Agenda Item # 2

BOA-002773-2023

1704 McGill Avenue

- Use, Access, and Parking Surface Variances to allow a duplex on a lot with sub-standard access and aggregate parking surface for a duplex in an R-1, Single-Family Residential Urban District.

SITE PLAN

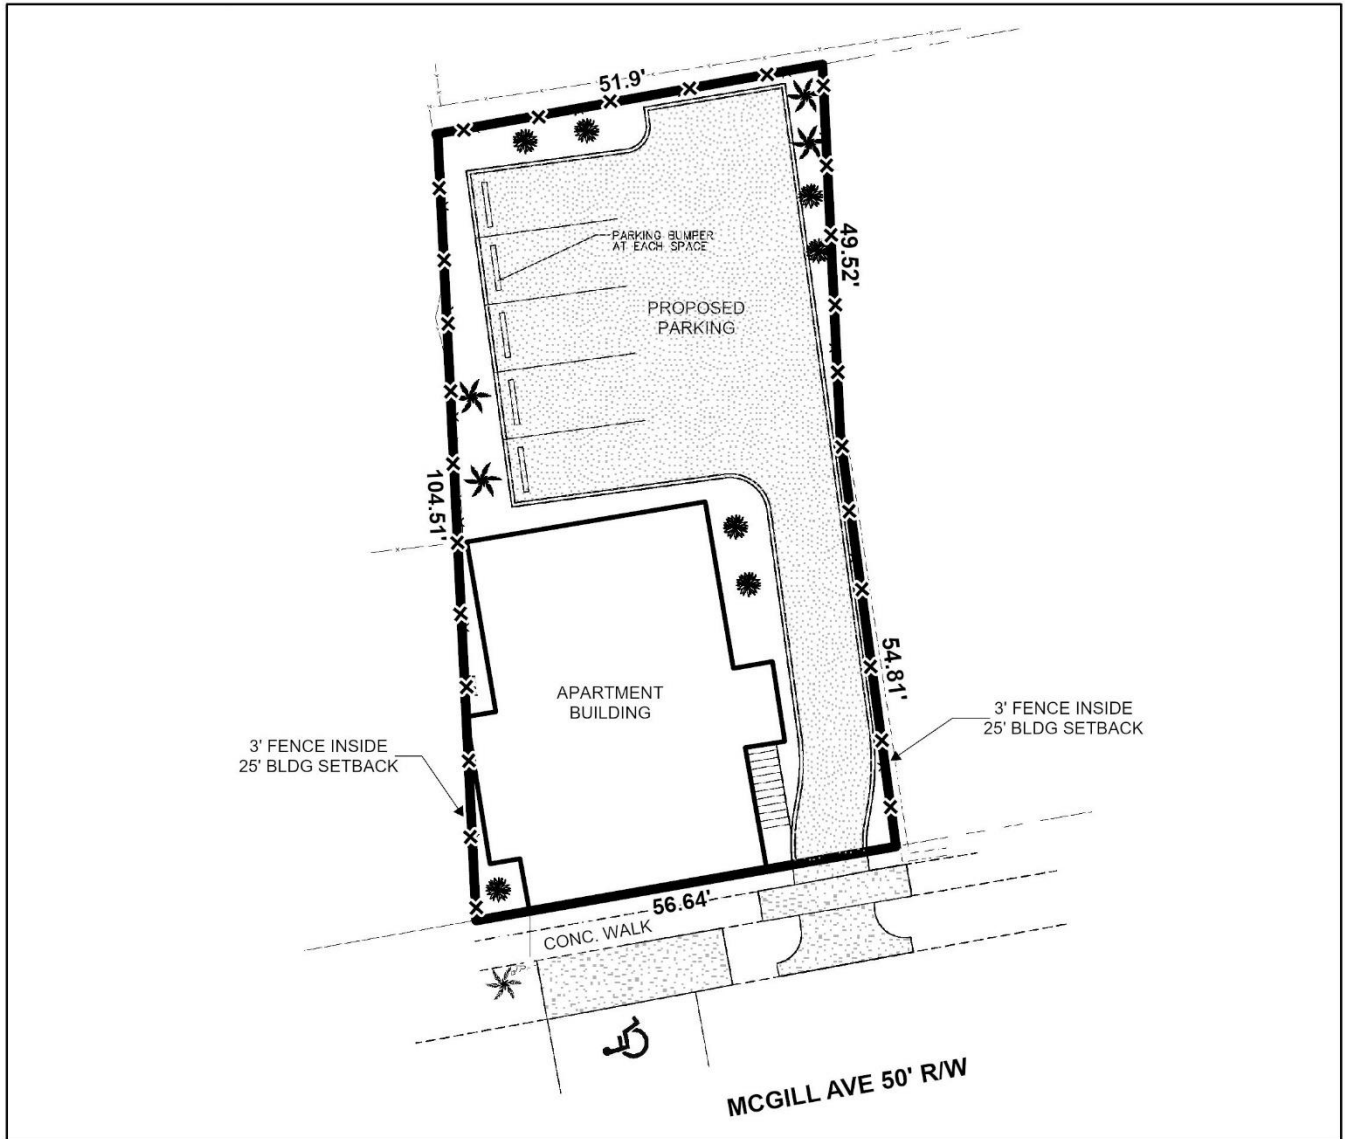
Providing the marked on-street parking does not allow for enough roadway width for two-way travel. For two-way travel two lanes are required and each lane shall be at least ten feet wide on residential streets. The roadway will need to maintain a total width of twenty feet. Although on-street parking is allowed on residential streets it is not marked and not reserved for any particular property. Traffic Engineering does not approve marked on-street parking on residential streets. Driveway number, size, location, and design to be approved by Traffic Engineering and conform to AASHTO standards. Any required on-site parking, including ADA handicap spaces, shall meet the minimum standards as defined in Article 3, Section 64-3-12 of the City's Unified Development Code.

The UDC requires all properties with two-way access to provide a driveway that is 24 feet wide. The site plan submitted illustrates a driveway that is 10 feet wide.
